CITY OF DOVER, DELAWARE
PLANNING COMMISSION
Monday, June 15, 2026 at 7:00 PM

2. S-26-11 Delaware State University Football Stadium Plaza at 1200 N Dupont Hwy – Public Hearing and Review of a Site Development Plan for a new 53,370 SF +/- Building with Stadium Plaza Complex and the associated site improvements. The project site will redevelop the south side (home stands) area at the football stadium located on the Delaware State University main campus. The property is zoned IO (Institutional and Office Zone) and also subject to the SWPOZ (Source Water Protection Overlay Zone): Tier 3 Excellent Recharge Area. Property Address: 1200 N. Dupont Highway. Tax Parcel: ED-05-057.00-01-21.00-000. Council District 4.

3. SB-26-02 Bay Village Residential Planned Neighborhood Design: Subdivision Plan - Public Hearing and Review of Preliminary Subdivision Plan for Bay Village Residential Planned Neighborhood Design Application. The property is 79.14 acres of land east of State Route 1 on the south side of White Oak Road and located south of the Garrison Oak Business and Technology Center. The property is currently zoned RM-2 (Medium Density Residence Zone) and subject to the Source Water Protect

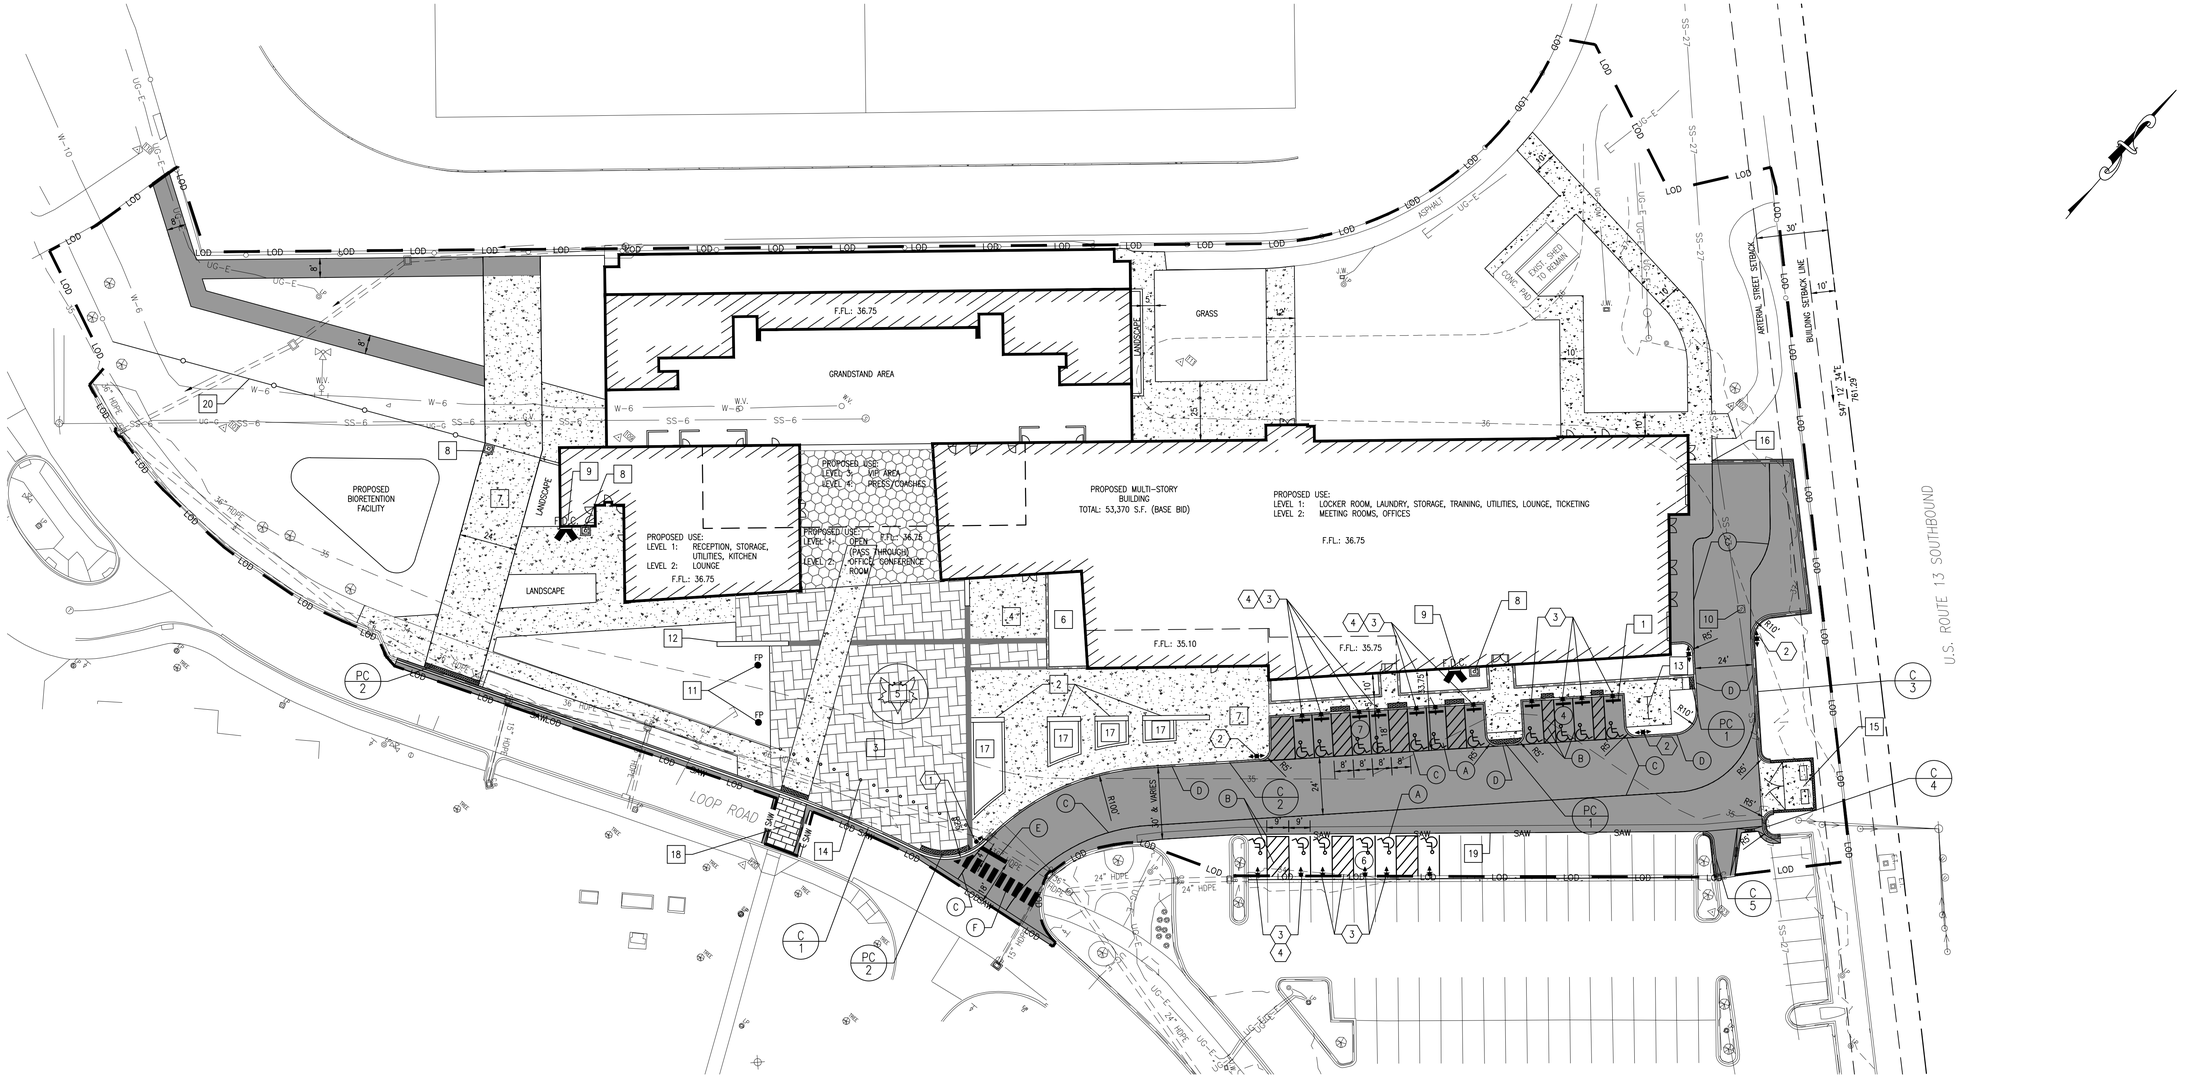
The site is required to provide bicycle parking. The minimum bicycle parking requirement is one (1) for every twenty (20) vehicle parking spaces. Sheet C300 includes a bicycle parking calculation which bases the required bicycle parking on 201 vehicle parking spaces, indicating eleven (11) bicycle parking spaces are required for the project. The calculation does not indicate the basis for 201 spaces; the applicant indicated it is the number spaces in the closest large parking lot to the stadium area. There is a parking lot at the southeast corner of the project area that extends beyond the identified project area.

SHEET C-202

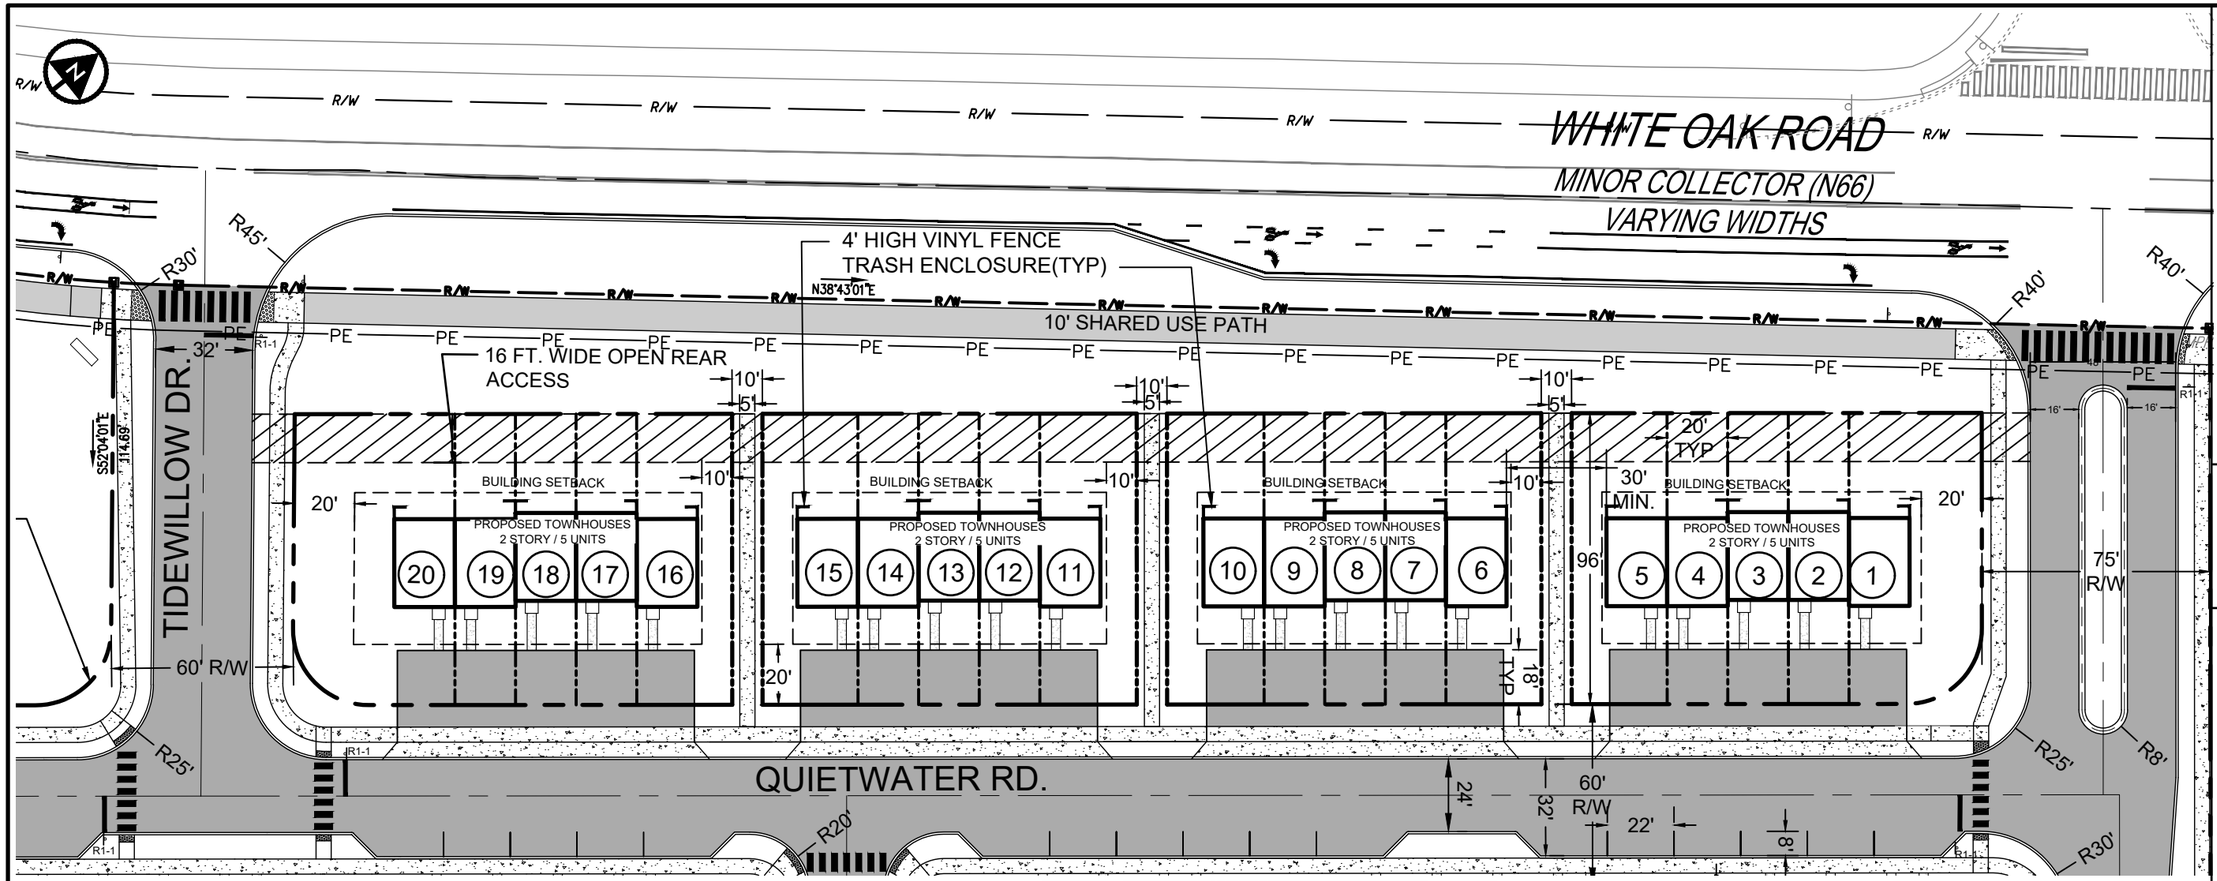
However, the series of Lots (1-20) along Quietwater Road does not include a rear alley. See the Emergency Rear Access Narrative to describe their approach for Lots 1-20 The Subdivision Plan (Revised Sheet C-202 and Lots 1-20 Exhibit) shows a 16 ft. wide Open Rear Access that runs parallel to the rear lot line as an "open rear yard" with proposed tree plantings between the lots and White Oak Road to their north. The plan shows that this Open Rear Access with a subgrade emergency access constructed. Ordinance provisions (Zoning and Subdivision Regulations) address the need to incorporate additional fire protection treatments in cases where townhouse units do not have rear alley access.

6) Plan Sheet C-202:
   a) The minimum required off-street parking dimensions are nine (9) feet in width and 18 feet in length. Please provide dimensions and labels for the required off-street parking in the Typical Townhouse Cluster schematic for the alley-loaded and front-loaded configurations. Also clarify paving material.
